<u> </u>		
Sheet: /		
File: bus.sch		
Title:		
Size: A3	Date:	Rev:
KiCad E.D.A. k	icad (5.1.10-1-10_14)	ld: 1/1
	7	β

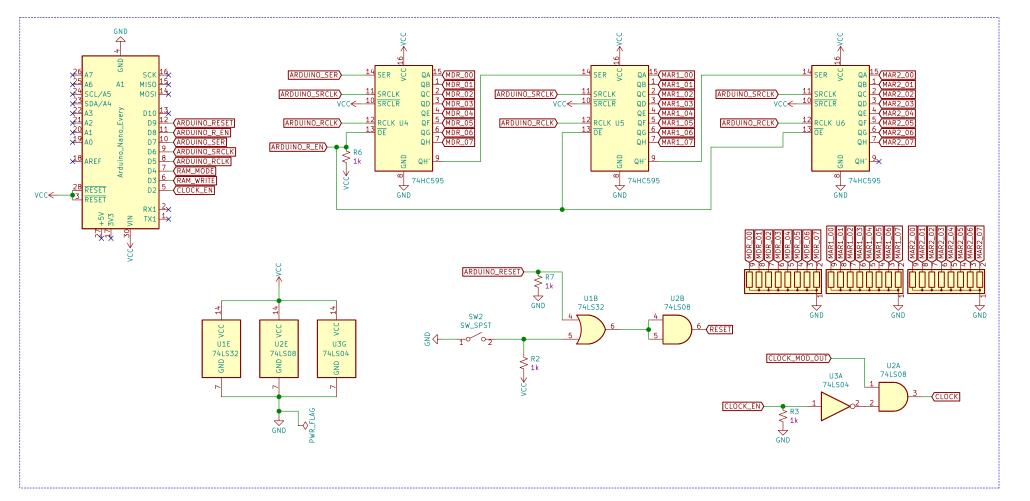
MAKE THIS SO YOU CAN MAKE AN ENCLOSURE

— IE. LIGHTS, AND PLUGS FOR POWER AND SPEAKER
SHOULD GO OFF THE BOARD

PERHAPS RENAME CONTROL PINS TO GENERICS SO THAT I CAN EVENTUALLY BUILD OUT THE BETTER SOUND CARD? PERHAPS I COULD ACTUALLY DECODE THE 3 BITS TO ALLOW FOR MORE CONTROL

WONDER IF I SHOULD REMOVE THE BUS CONTROL FROM EACH MODULE AND INSTEAD, INCLUDE THEM DIRECTLY ONTO THIS BOARD
